**ANGEL PLACE
LEVEL 8, 123 PITT STREET
SYDNEY NSW 2000**

9 June 2022

SECTION 4.55(1A) - MODIFICATION TO AMEND SSD 10438 - WATERLOO METRO QUARTER OSD BASEMENT

Figure 3 Approved Basement Plan Level 00

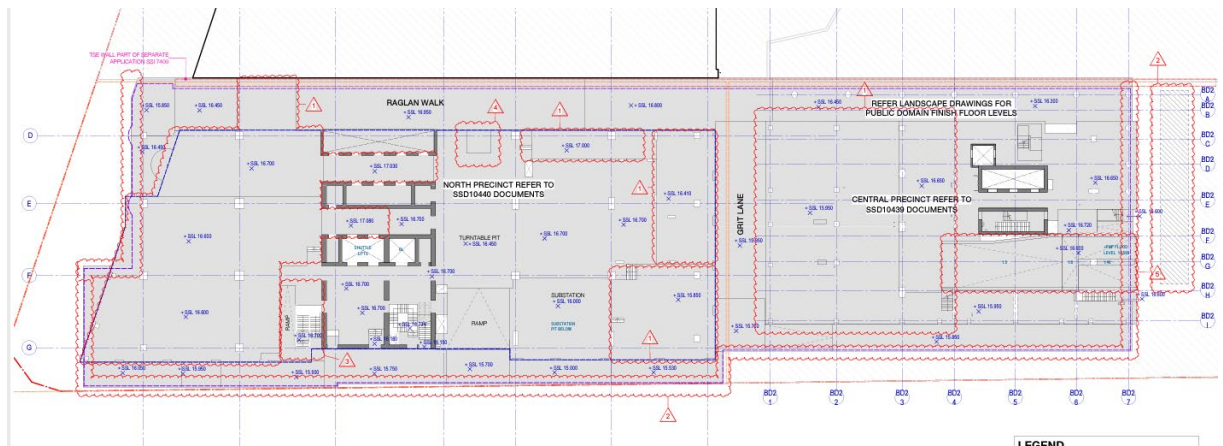
- Reduction in footprint and excavation volume of the basement by approx. 200 m² and 1400 m³.
- Refinement and reconfigure of services elements.
- Relocation of the End of Trip Facilities to align with the Northern and Central Precinct requirements.

- Introduce one way circulation aisles in the northern section of the car park on both levels.
- Consolidate the residential parking onto Basement Level 1. Reconfigure the layout of car parking spaces to provide a more logical and efficiency basement layout.

- Slab levels on ground levels adjusted to suit the requirements of the flood analysis.
- Onsite stormwater detention tank design has been further developed by the civil engineer and coordinated with landscape to maximise deep soil in Church Square. This has resulted in the change to the footprint of the onsite stormwater detention tank. The onsite stormwater detention tank can continue to comply with stormwater requirement.

Figure 12 Proposed Area Plan

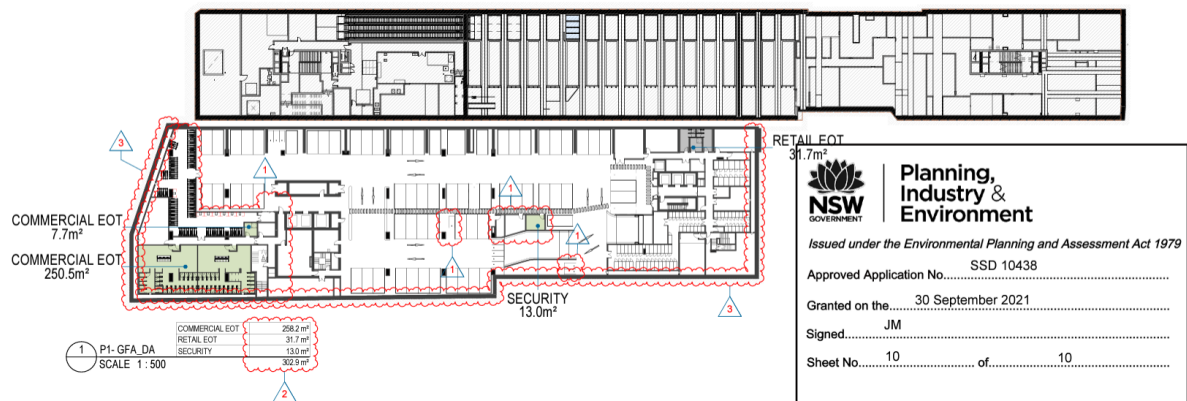
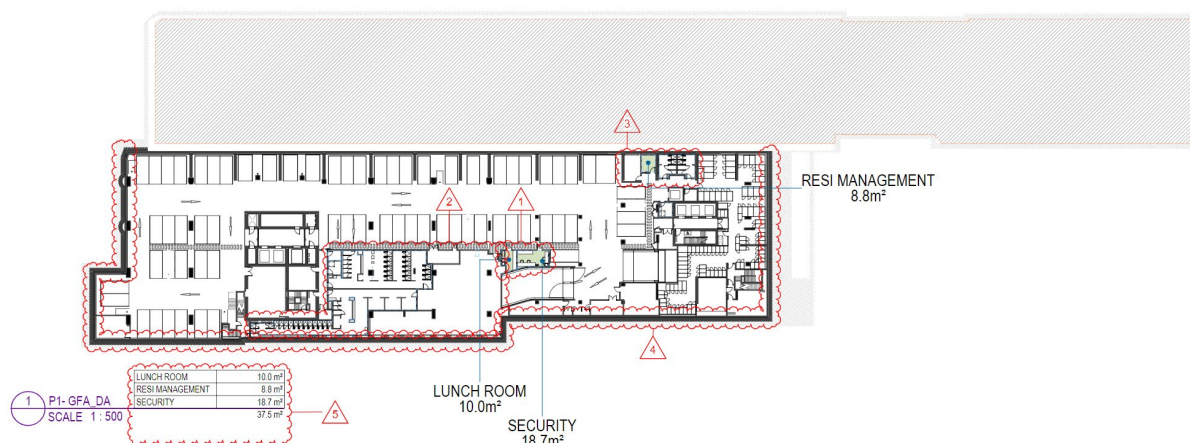
The approved area plans included commercial and retail end of trip facilities (EOTF) and security office within the basement area as part of the GFA calculation (refer to Figure 11).

The EOTF as detailed in updated Area Plan (see Figure 12), comprise bathrooms, showers, lockers and other bicycle storage, which constitute non-habitable rooms and storage that do not meet the applicable definition of GFA. Therefore, they are excluded from the calculation of GFA.

Accordingly, this application seeks to remove the designation of the EOTF as GFA from the ‘Area Plan’ (as there is no condition that limits GFA in the basement). The other habitable rooms such as the lunchroom, management office and Security Room will remain designated as GFA. This means that the total approved GFA across the site will not exceed the FSR control, notwithstanding the minor increase in the area of the EOTF proposed in this modification.
